Re: CPV Sentinel Energy Project: Docket No. 07-AFC-3

# Analysis of CEC Staff Alternative Water Supply Plans

## Application for Certification (07-AFC-3)

## CPV Sentinel Energy Project Riverside County, California

**Figure 1: Contour Map of Simulated Groundwater Level Changes at 30 Years – Simulation BC\_A.1**  
 (Water consumption = 550 AFY from on-site wells, DWA recharge = 593 AFY, Tyley’s T, anisotropy ratio = 2.0)

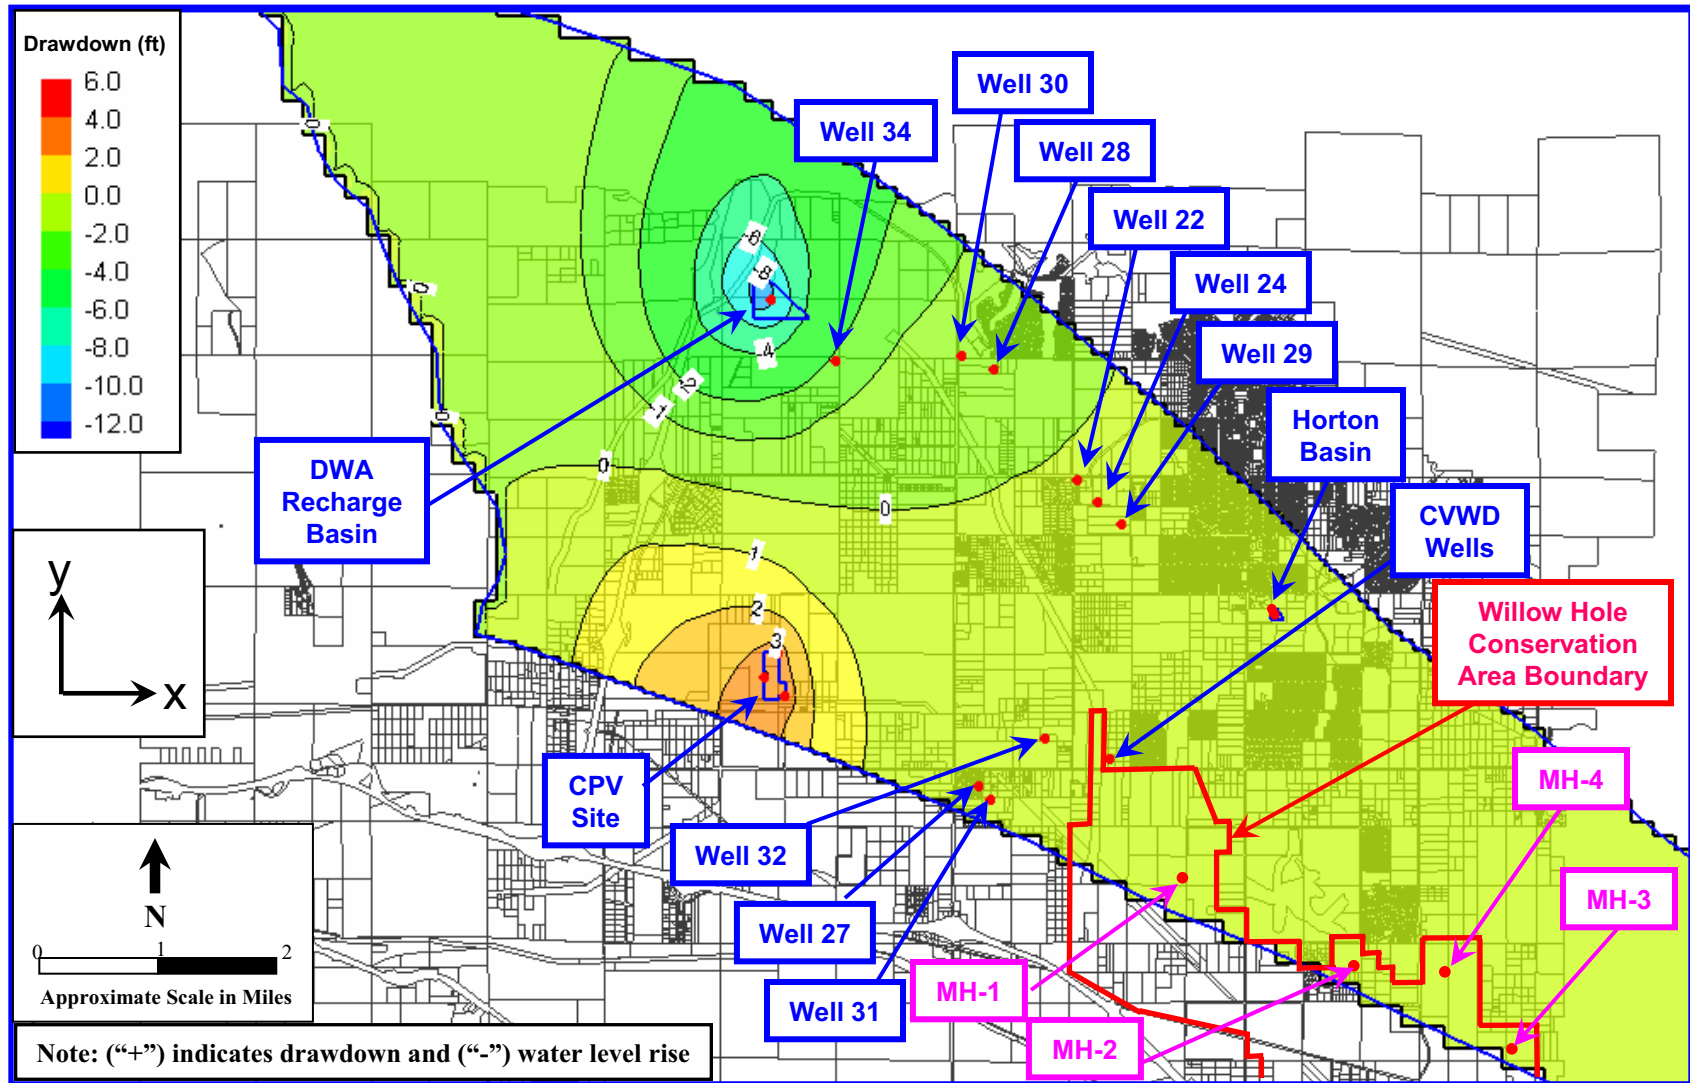
pumping is equal to the expected extractions of the CPVS (550 AFY) and the project-specific recharge net of evaporative losses during spreading (593 AFY). Figure 1 shows the estimated contours from this simulation. Table 1 shows the estimated drawdown at various points of interest in the sub-basin.

**FIGURE 6**

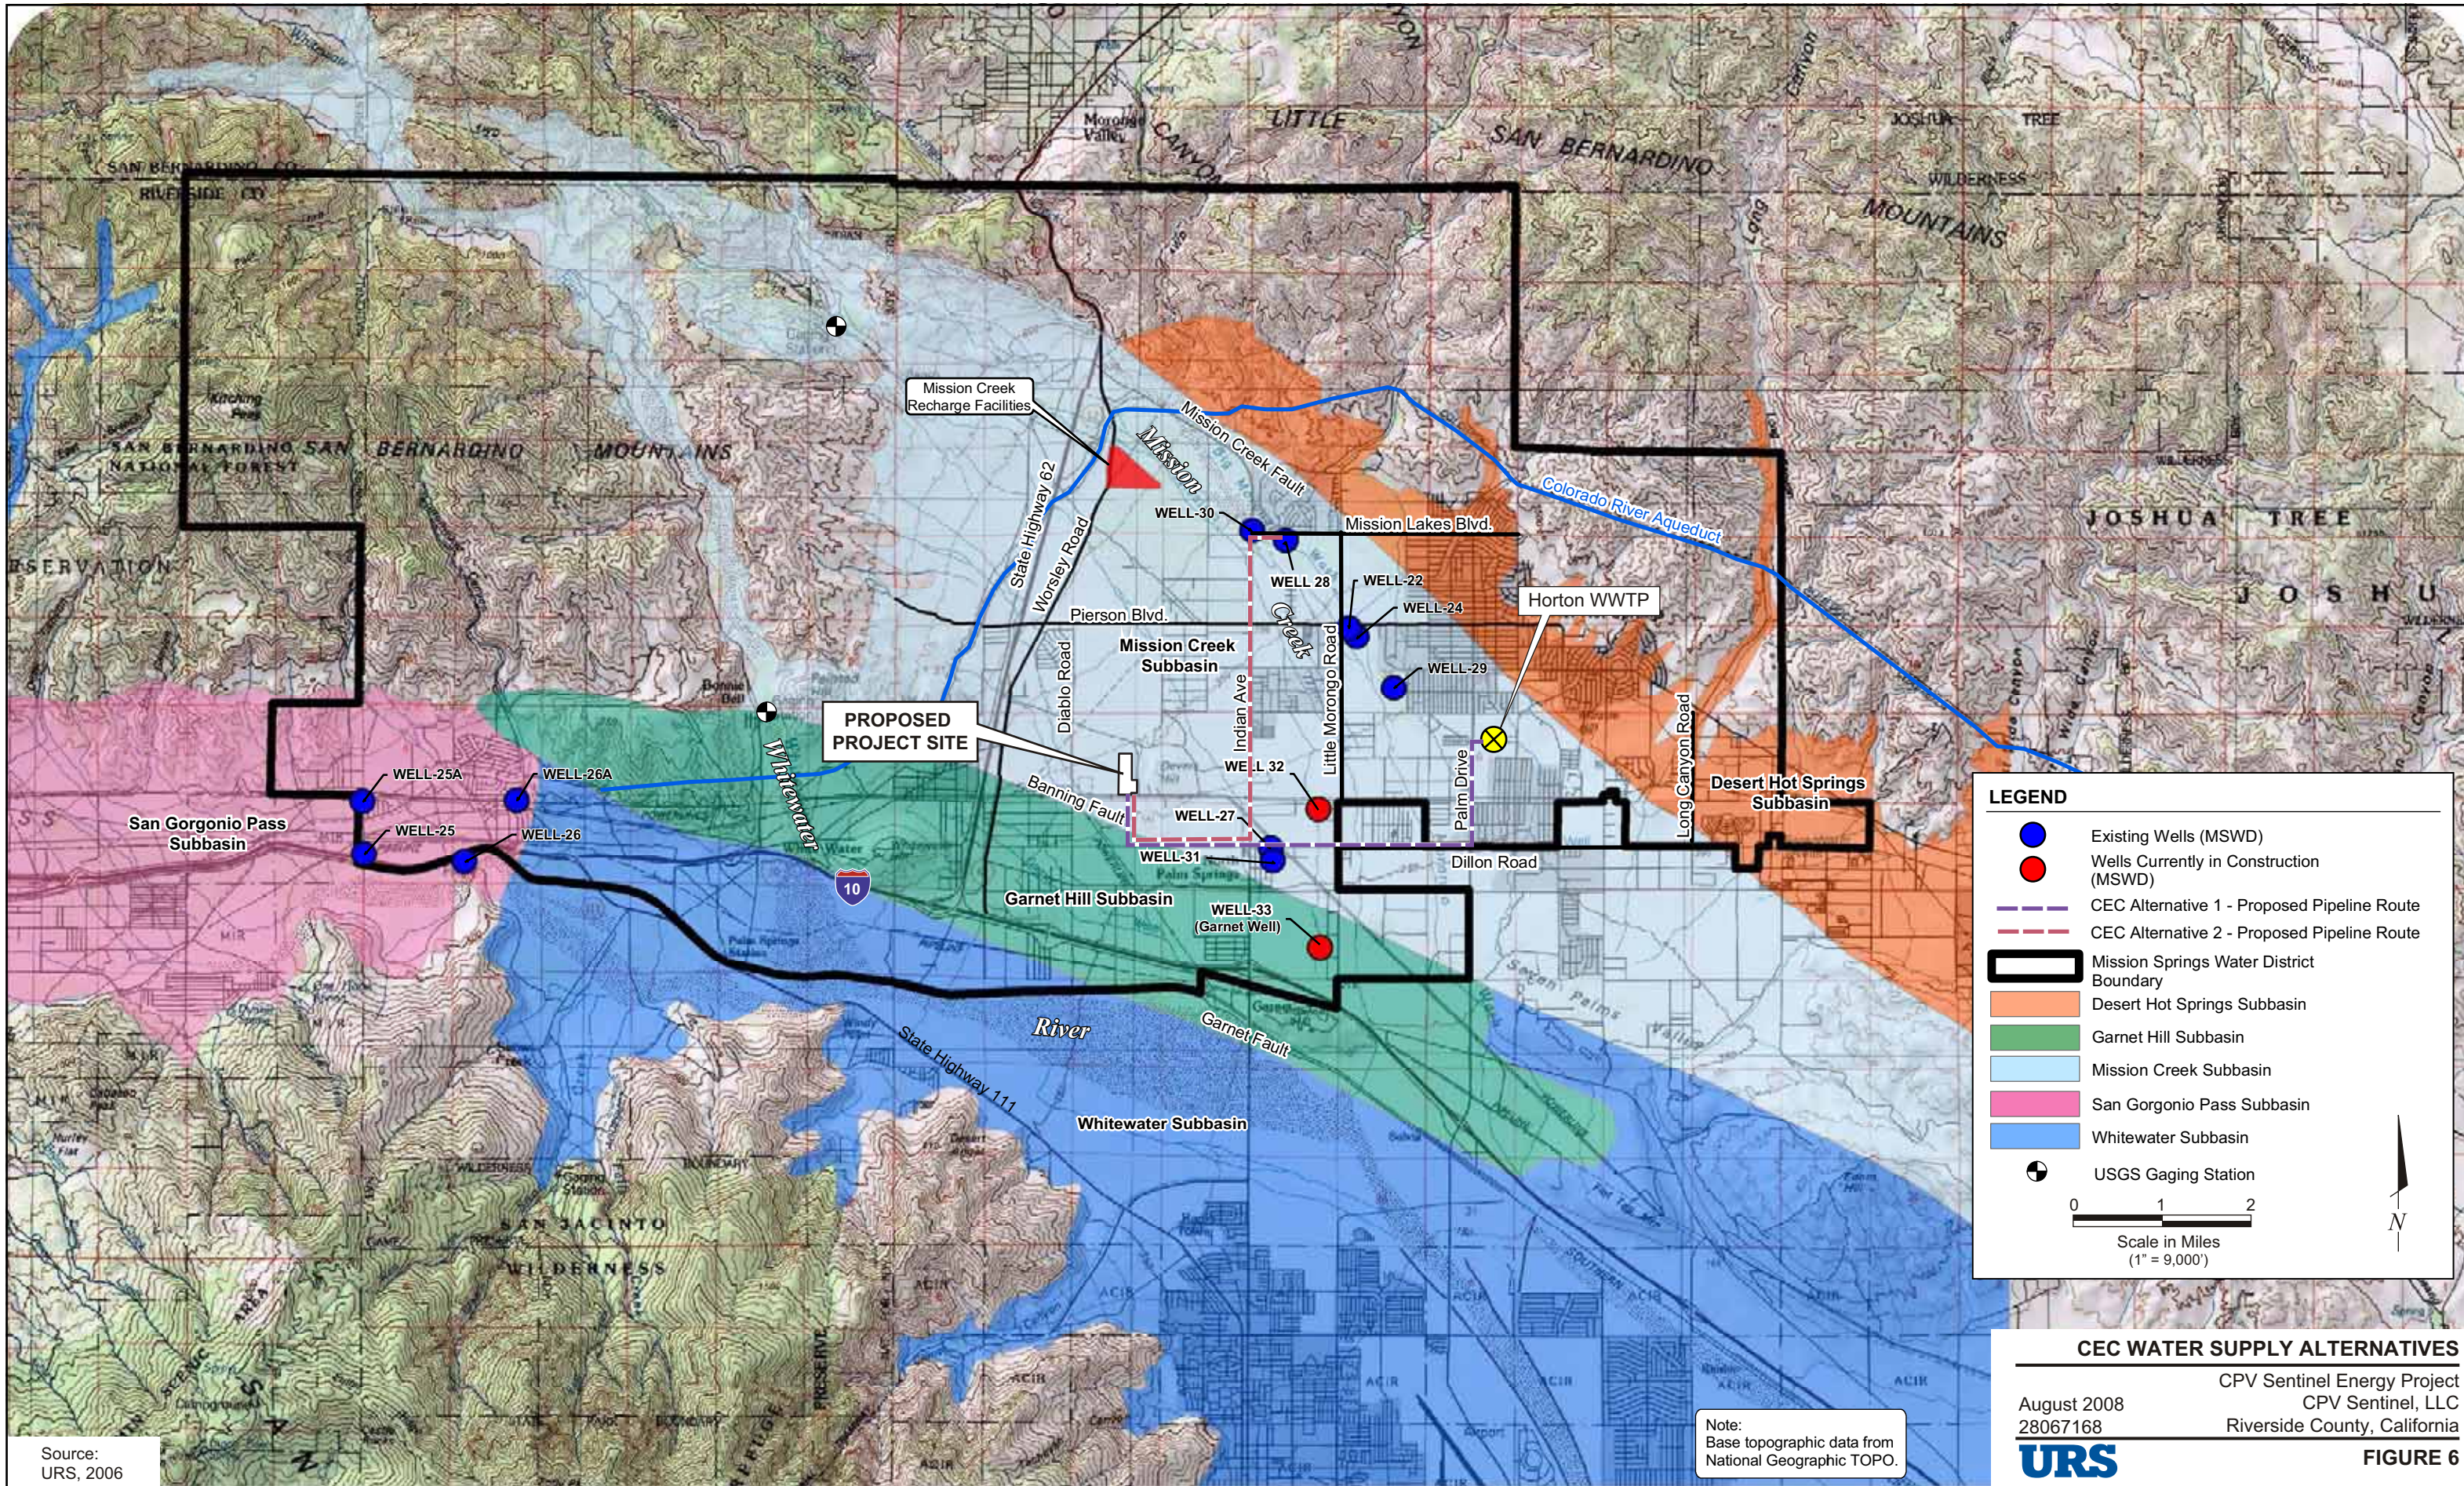
CEC staff water supply alternatives also involve the construction of 6 miles of new pipeline from the HWTP to the project site and in the case of Alternative 3, the construction of approximately 6 miles of new pipeline from MSWD Wells 28 and 30 to the project site. The water supply pipelines would both cross intermittent streams as shown on Figure 6.

**Line 1:** An offsite groundwater supply pipeline would only be needed for CEC staff Alternative 2. It would be 5.25 to 6.4 miles in length, depending on the final route. As illustrated in Figure 6, this pipeline would cross seasonal washes; as such, it may require special engineered provisions to prevent erosion or possibly a directional drill to avoid cutting into the seasonal wash. This pipeline is estimated to cost \$900,000 per mile rather than \$600,000 per mile in the CEC staff cost estimate.

**Line 2:** An offsite reclaimed water supply pipeline is required for both CEC staff Alternatives 1 and 2. It will be approximately 6 miles in length, and would cross two seasonal washes, as illustrated in Figure 6. It also is priced at \$900,000 per mile rather than \$600,000 per mile, as noted in the CEC staff cost estimate.
